EN 1998-2:2005/A1

**Eurocode 8: Design of structures for earthquake resistance -
Part 2: Bridges**

This amendment A1 modifies the European Standard EN 1998-2:2005; it was approved by CEN on 12 February 2009.

Figure 7.4: Acceleration and displacement spectra

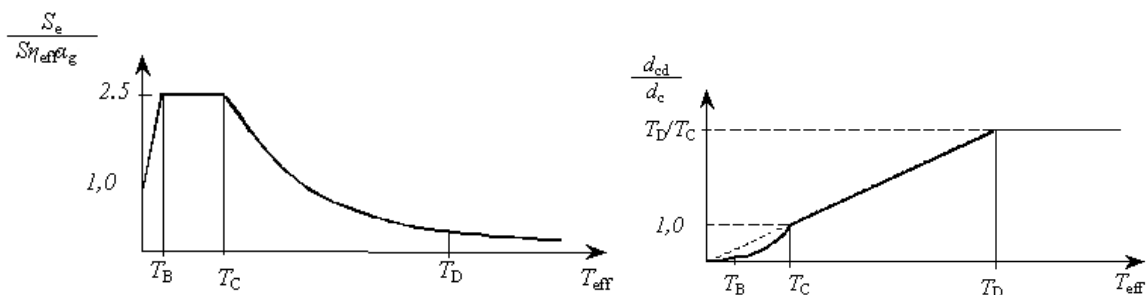
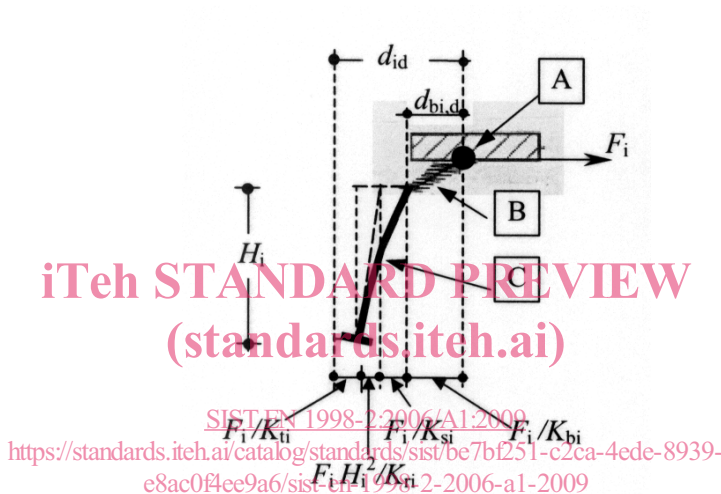
3) In 7.5.4 Fundamental mode spectrum analysis

Replace (3) by:

(3) This leads to the results shown in Table 7.1 and Figure 7.4.

T_{eff}	S_e	d_{cd}
$T_C \leq T_{\text{eff}} < T_D$	$2,5 \frac{T_C}{T_{\text{eff}}} a_g S \eta_{\text{eff}}$	$\frac{T_{\text{eff}}}{T_C} d_C$
$T_D \leq T_{\text{eff}} \leq 4 \text{ s}$	$2,5 \frac{T_C T_D}{T_{\text{eff}}^2} a_g S \eta_{\text{eff}}$	$\frac{T_D}{T_C} d_C$

$$d_C = \frac{0,625}{\pi^2} a_g S \eta_{\text{eff}} T_C^2 \quad (7.8)$$

$$\eta_{\text{eff}} = \sqrt{\frac{0,10}{0,05 + \xi_{\text{eff}}}} \geq 0,40 \quad (7.9)$$
